ORIGINATION FORM

Proposed Revisions to a Standard Plans Index
(Please provide all information — Incomplete forms will be returned)

PEDESTRIAN/BICYCLE
BULLET RAILING DETAILS

INDEX	SHEET
515-022	3 of 3

LAST REVISION 11/01/17	REVISION	DESCRIPTION:	 FY 2020-21 STANDARD PLANS	PEDESTRIAN/BICYCLE BULLET RAILING DETAILS	INDEX 515-022	SHEET 3 of 3
---------------------------	----------	--------------	----------------------------------	--	------------------	-----------------

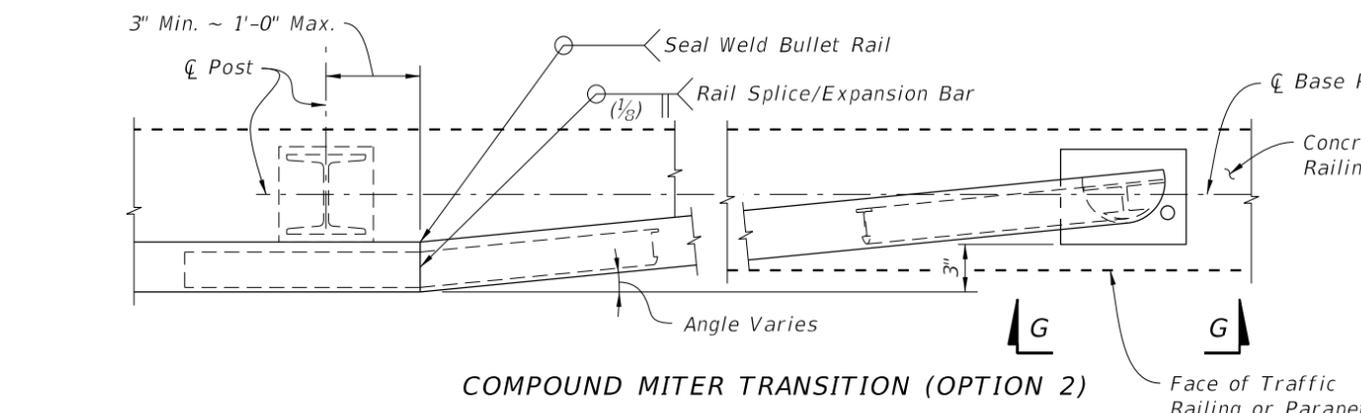
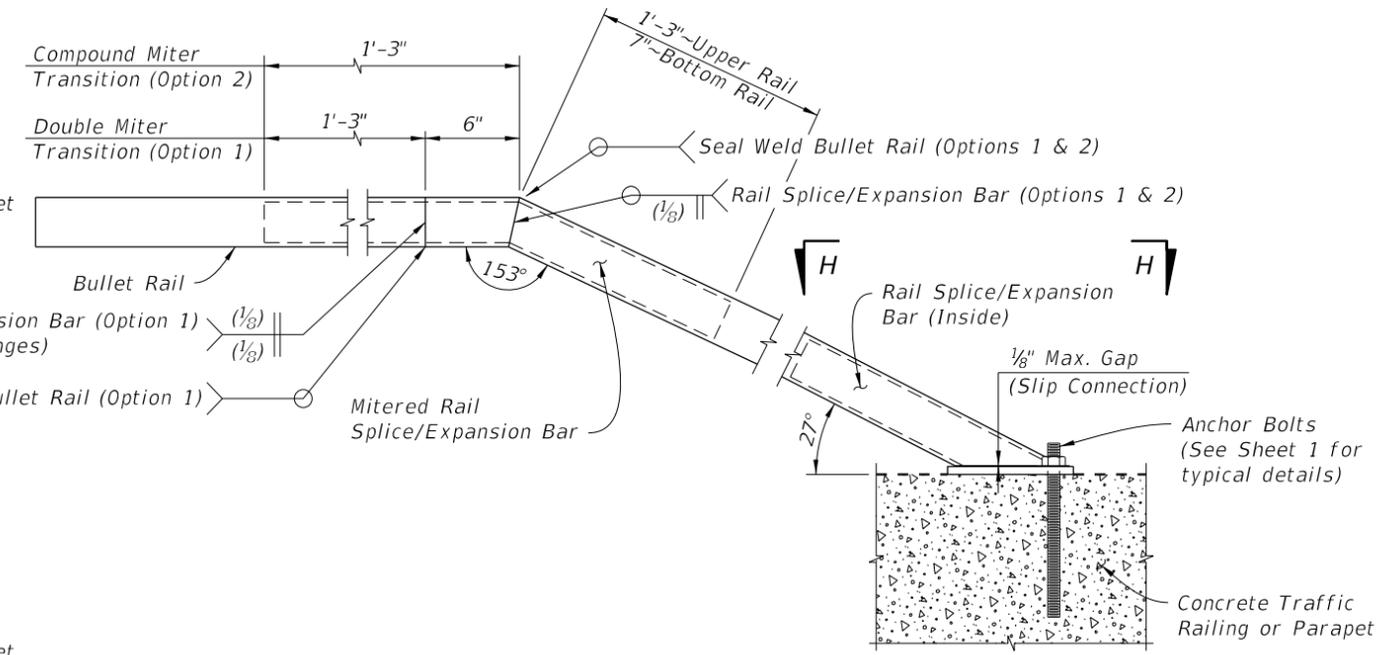
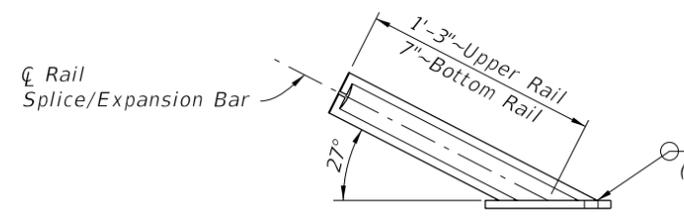
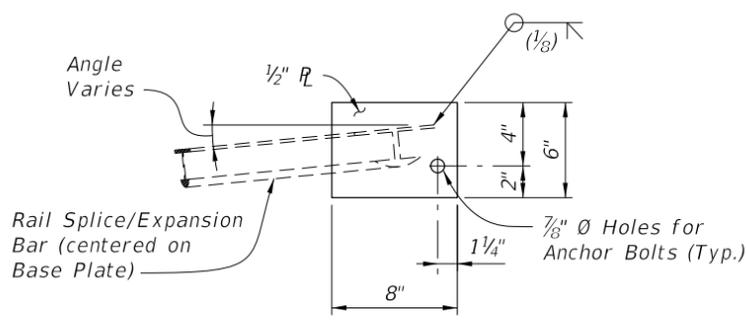
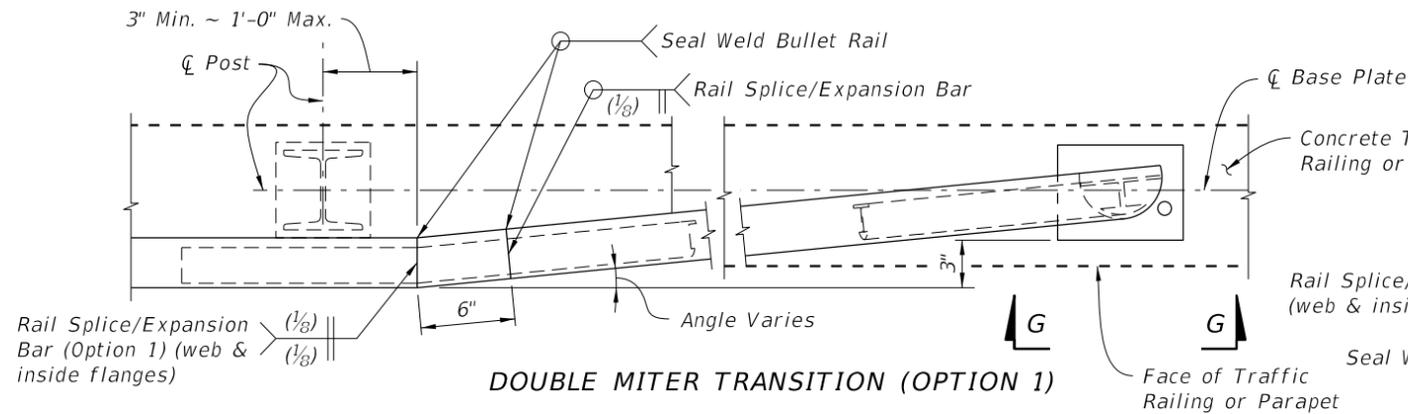
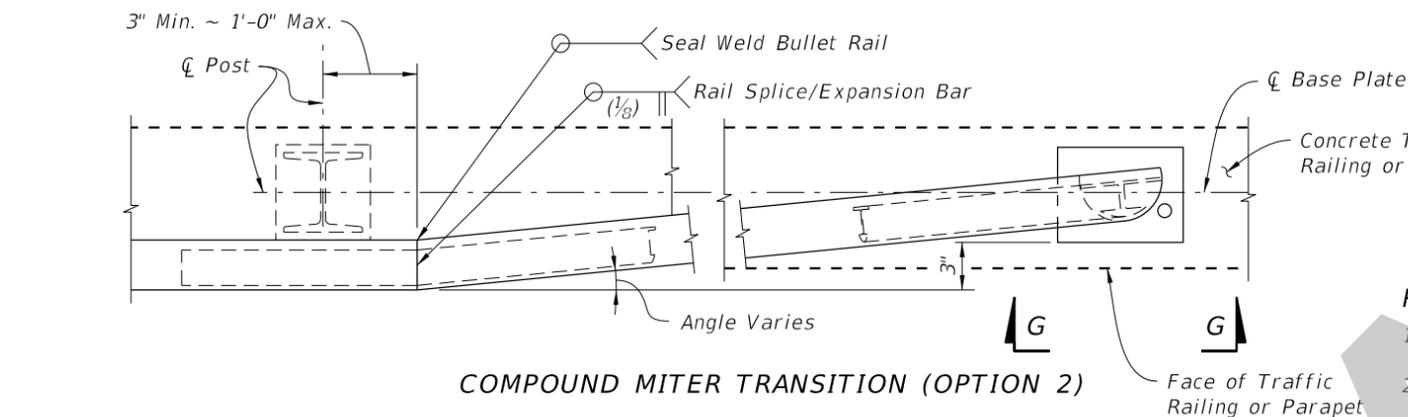
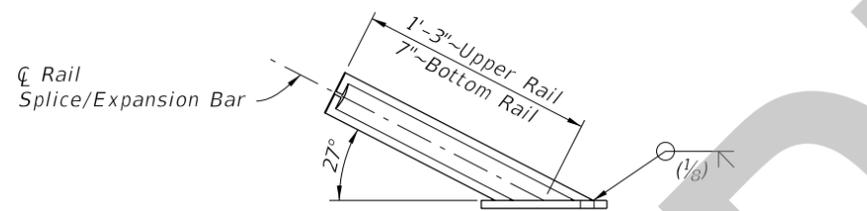
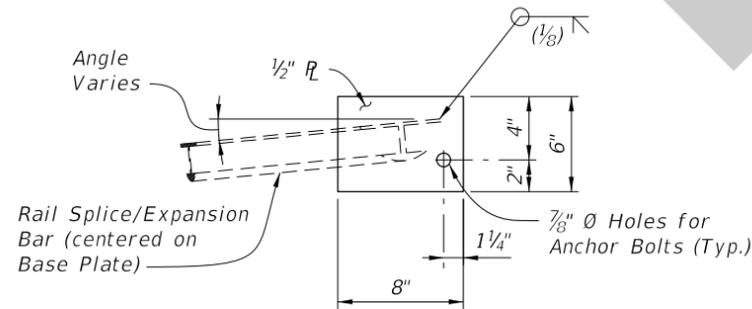
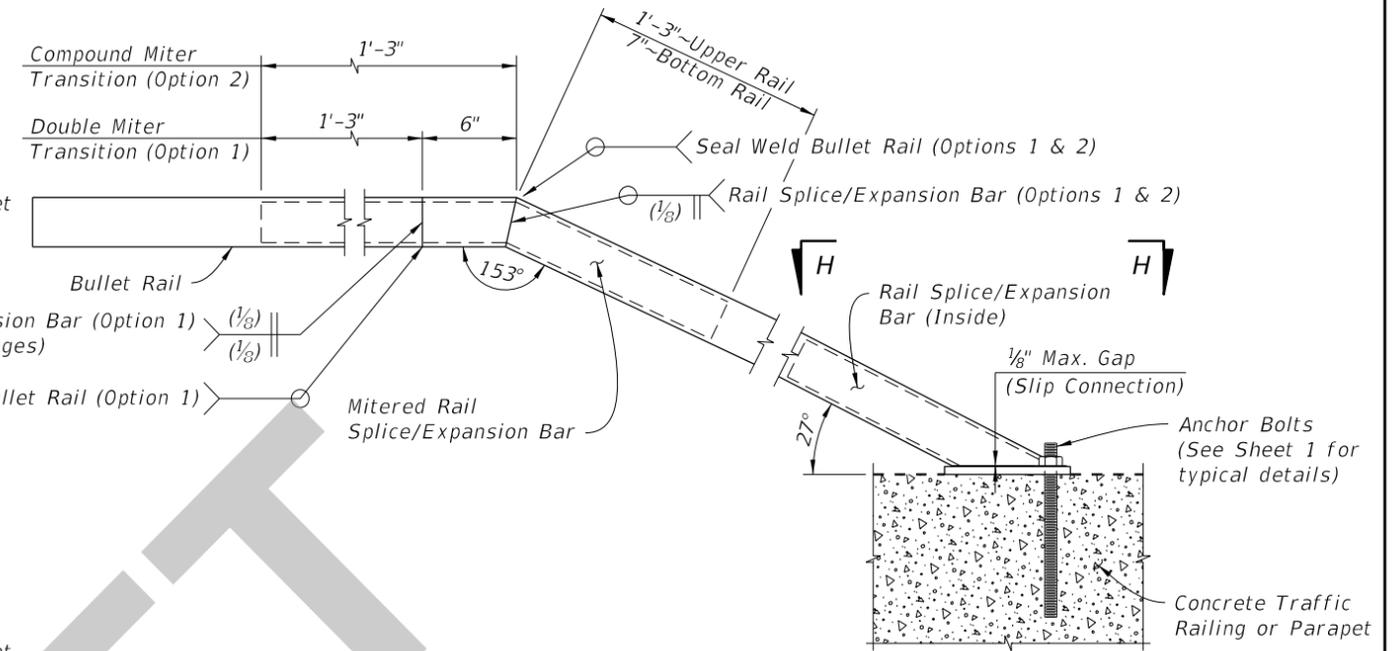
D. Anchor Bolts: Galvanized ASTM A307 Grade 36 Hex Head. ASTM 1554 Grade 55 Threaded Rods for Adhesive Anchors

- D. Anchor Bolts: Galvanized ASTM A307 Grade 36 Hex Head. Galvanized ASTM 1554 Grade 55 Threaded rods for Adhesive Anchors.
4. Layout:
 - A. Posts shall be uniformly spaced with reasonable consistency.
